Hillingdon

Outline Fire Strategy – Rev E

OF-OFS-3671-01-E

Appendix A – Drawing Comments

1 Building 8 - Ground Floor Plan
1 : 200

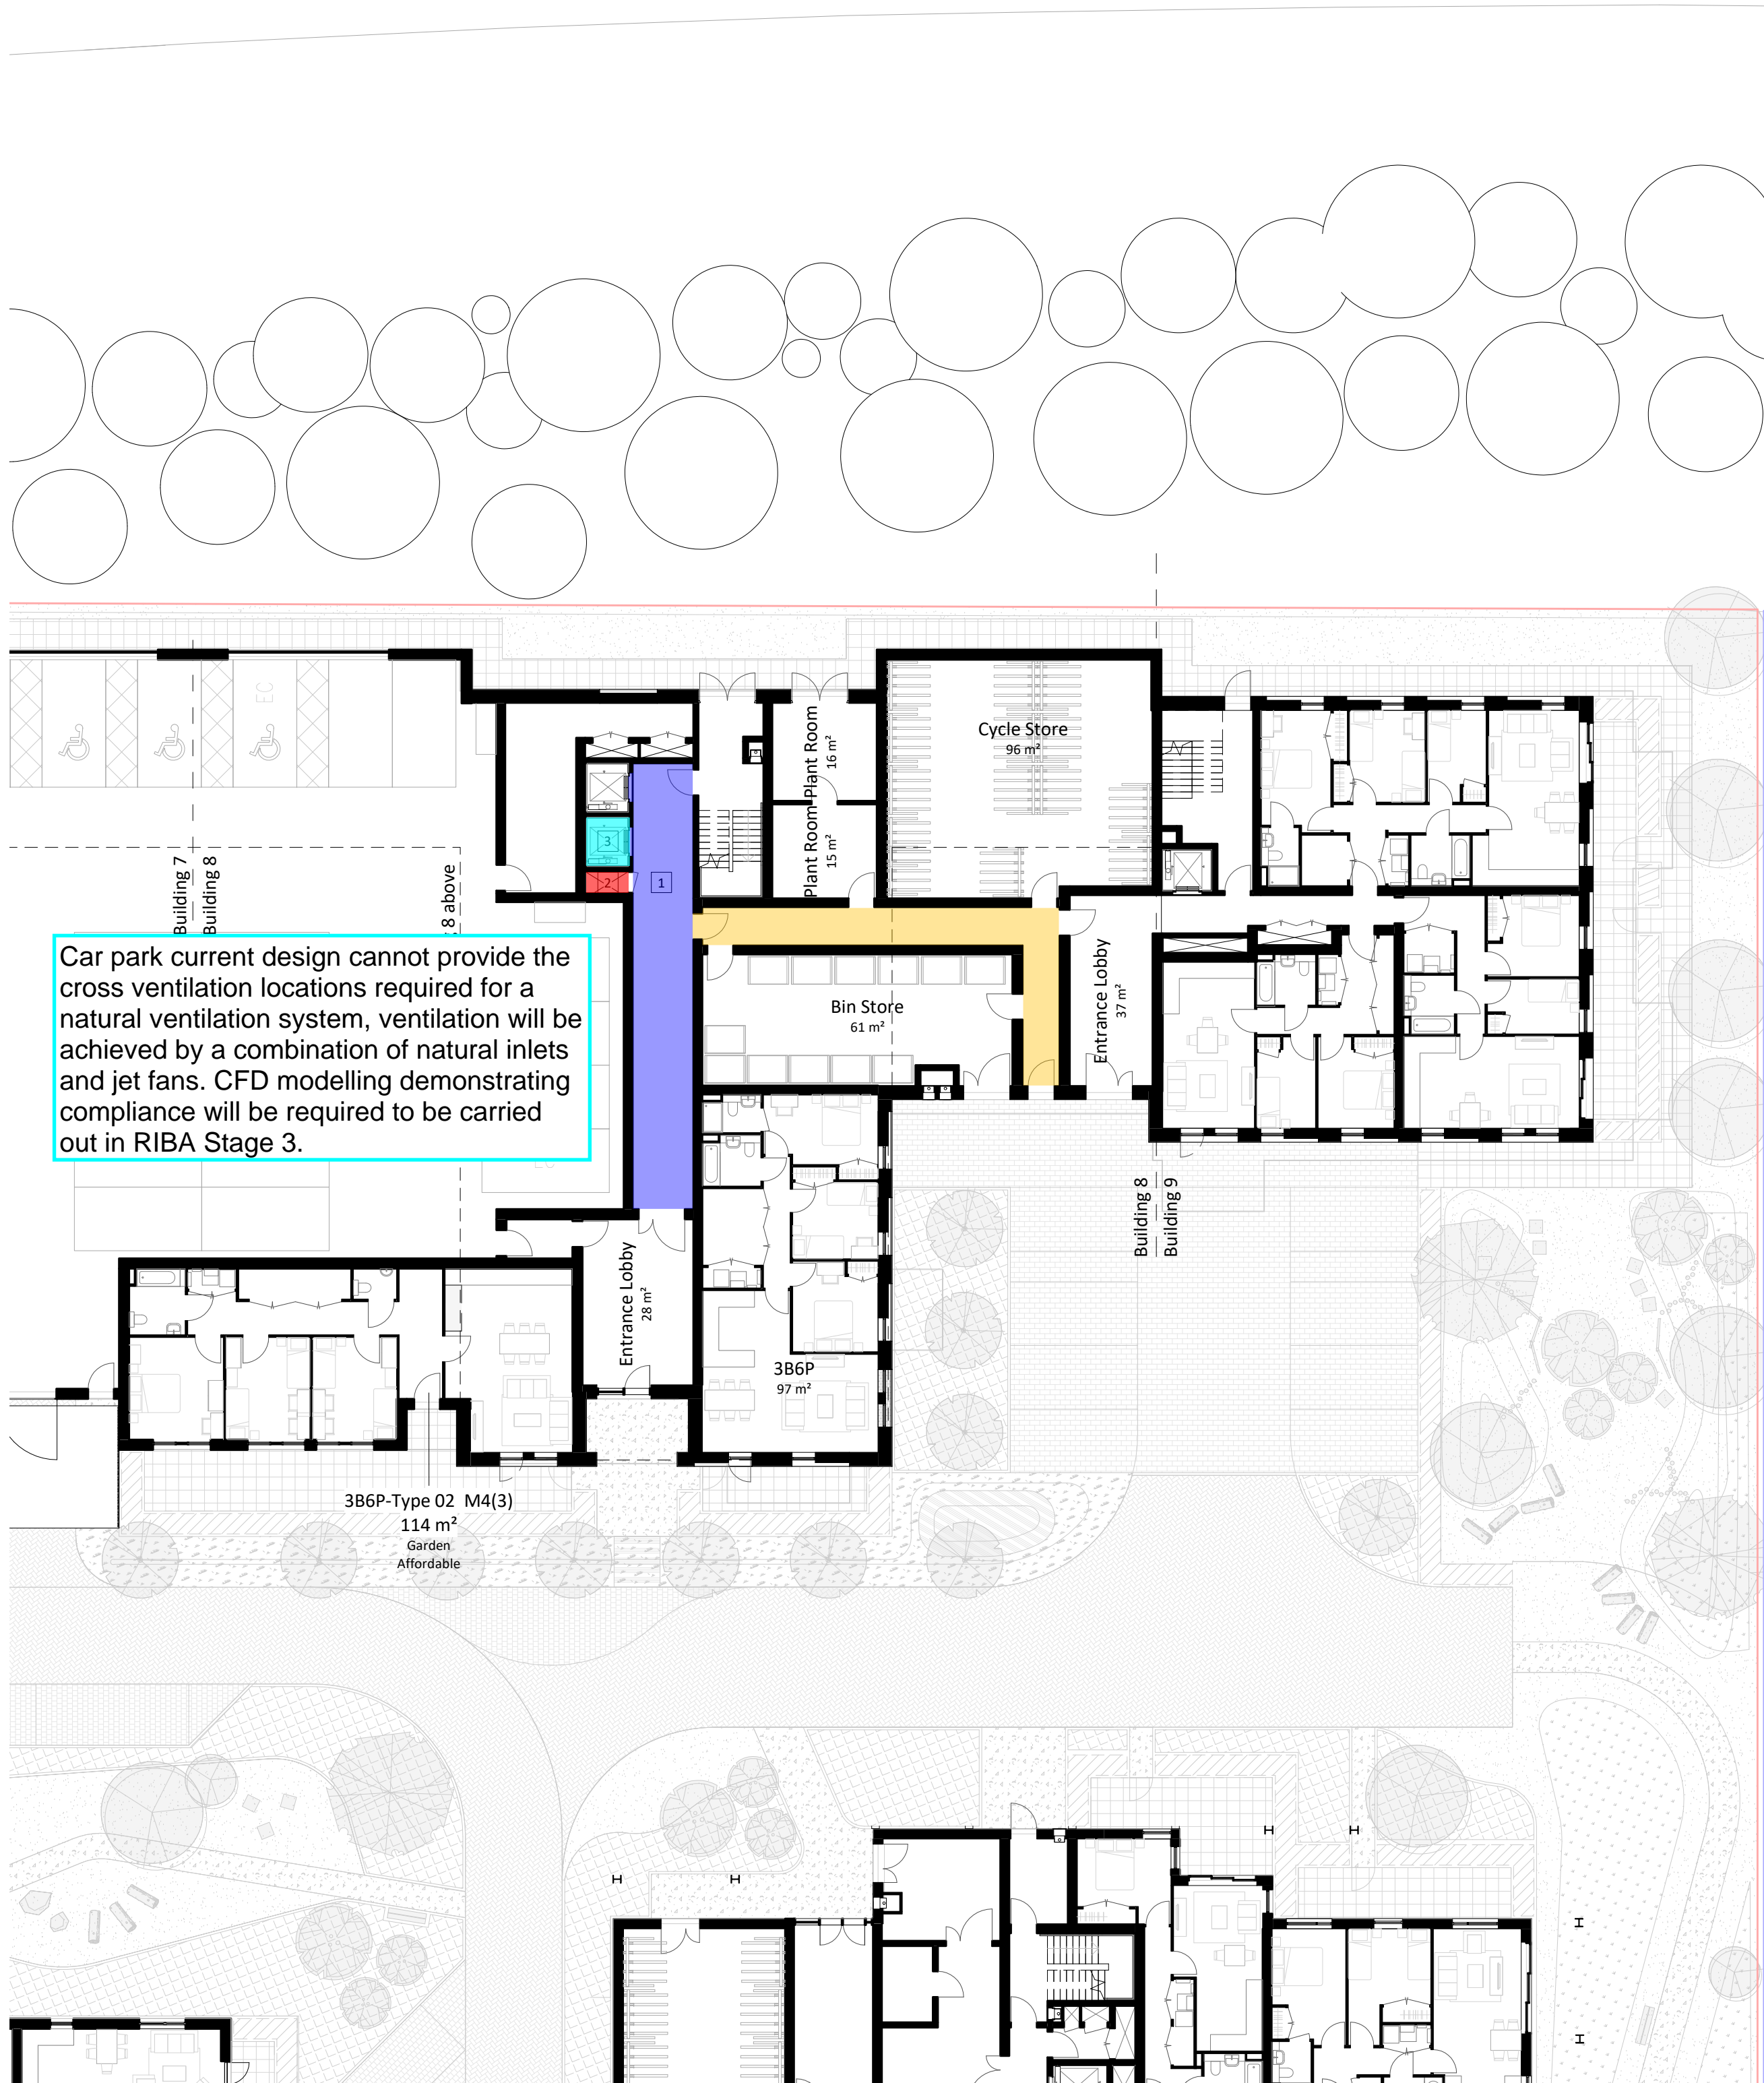
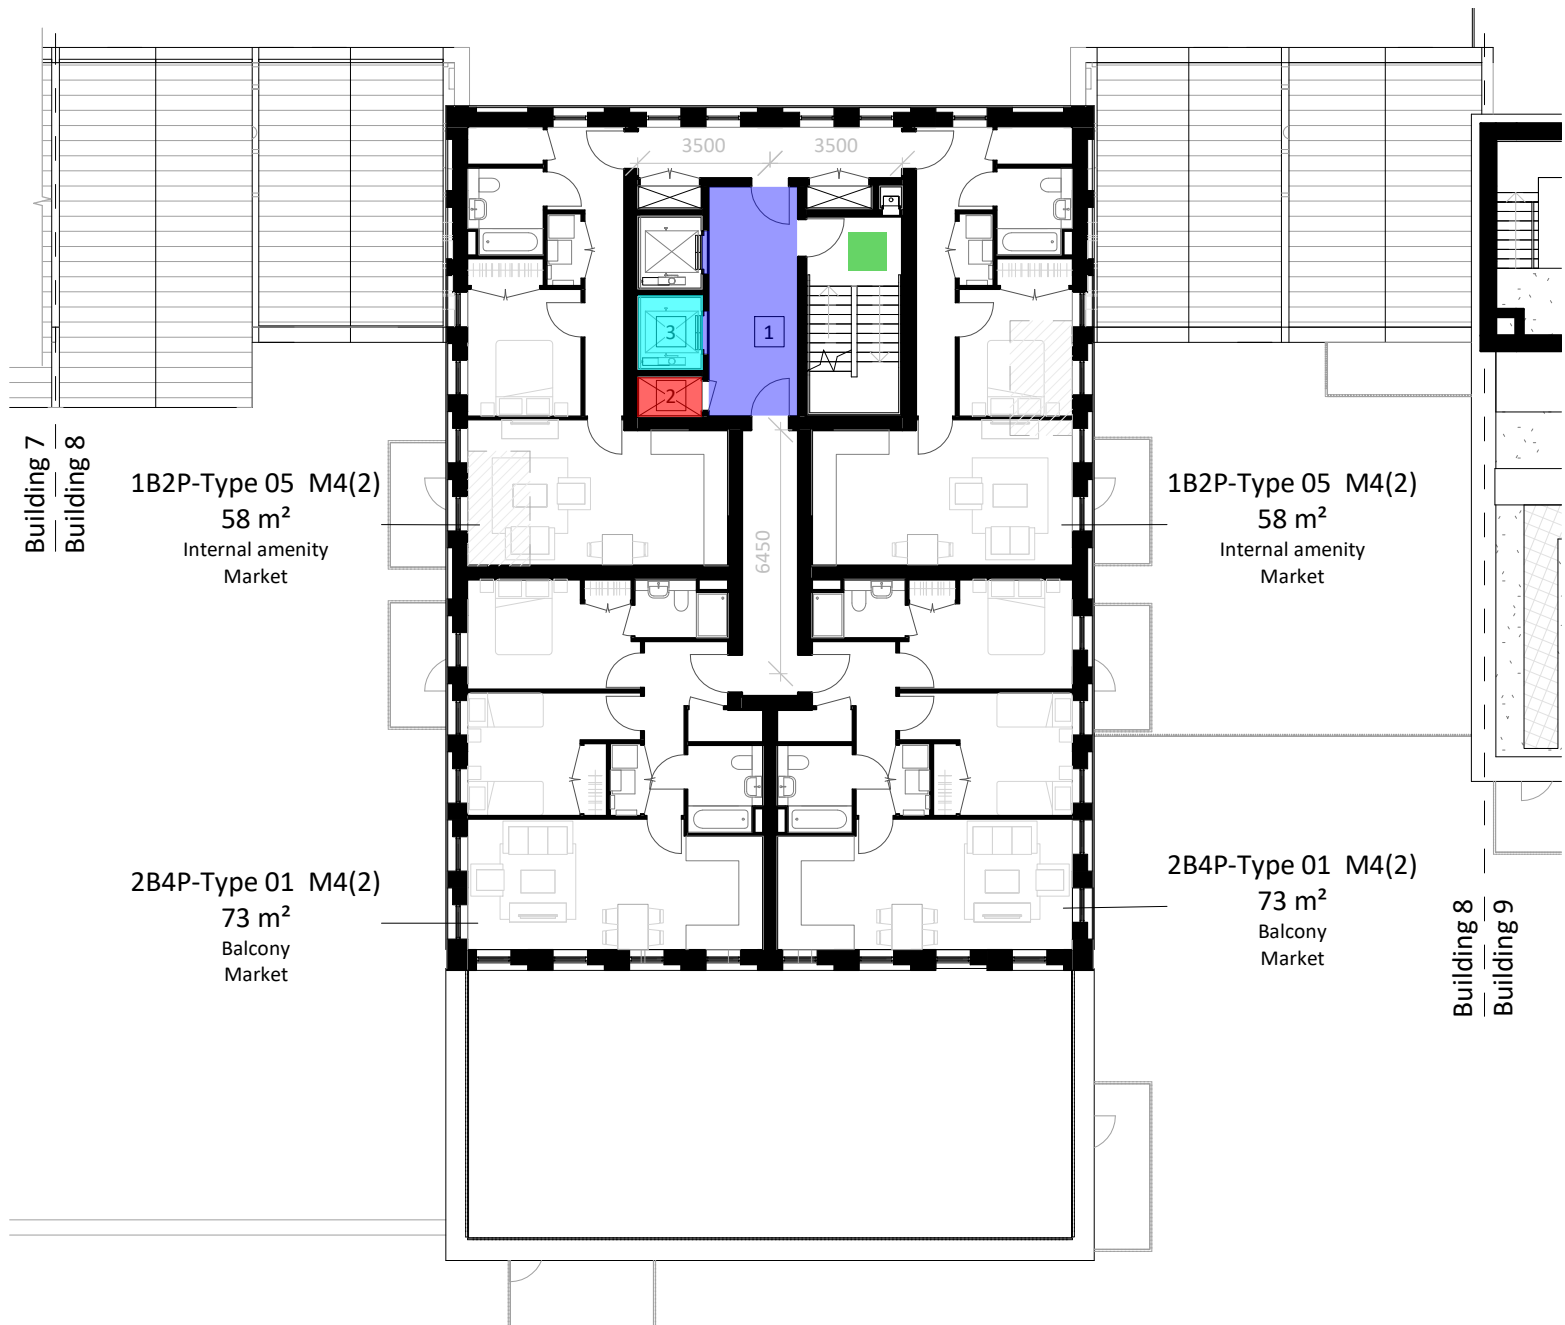
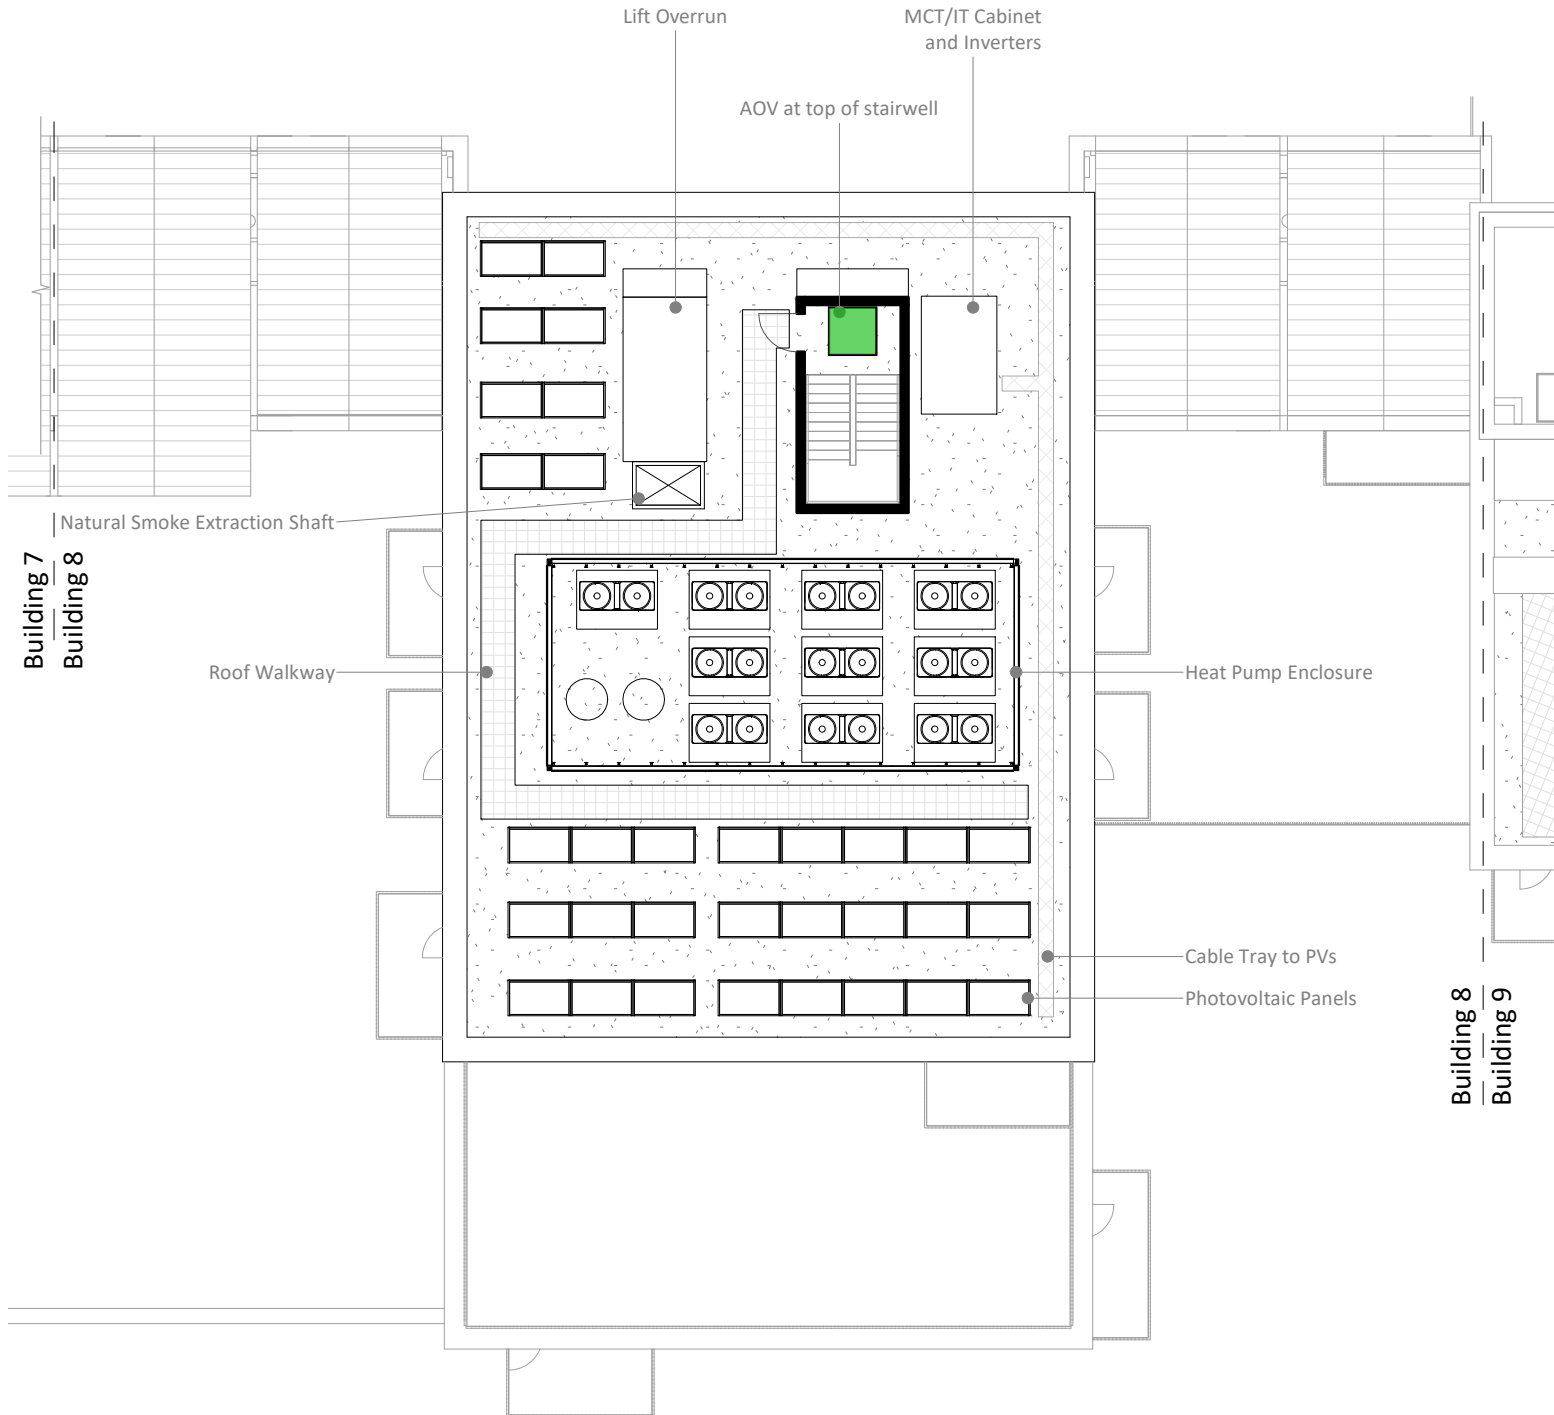
To be noted, the government have stated from May 2020, all new building's over 11m in height are required to be provided with sprinklers, see Section 9.

To be noted, if the service riser is to only contain water services or metal ventilation ductwork from the ground floor, it is considered a limited fire hazard. As such, this riser shaft may be located in the staircase lobby.
